PanelView 1200 Operator Terminals

2711-KA1, KC1, TA1, TC1, TA4, TC4 Series F

Firmware Release Version 5.10.00, 5.13.00

If you installed Keypad Firmware on a Touch Screen Terminal:

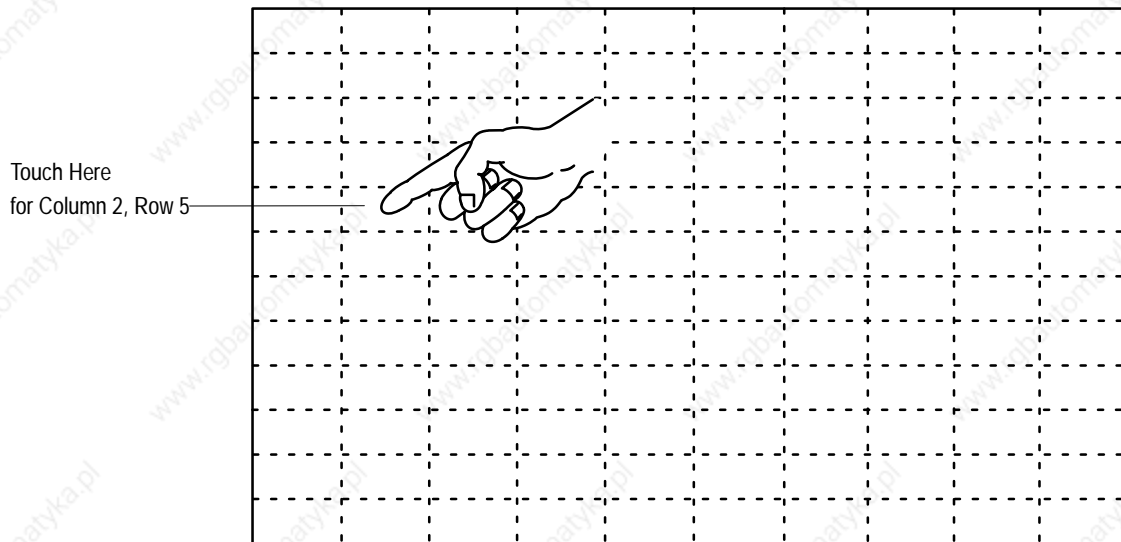
- 1 Do one of the following:

- If the PanelView terminal is turned off, power it up in Run mode, then switch it to Configure mode.

- If the terminal is powered up in configure mode, press the touch cell at Column 4 and Row 9 (the point of origin is at the top left of the touch screen). This will clear the error message at the bottom of the screen.

2 Press the touch cell at Column 2 and Row 5

3 Restart the download at the DOS prompt by typing

```
DOWNLOAD ACC_TUCH.BIN [COM2]
```
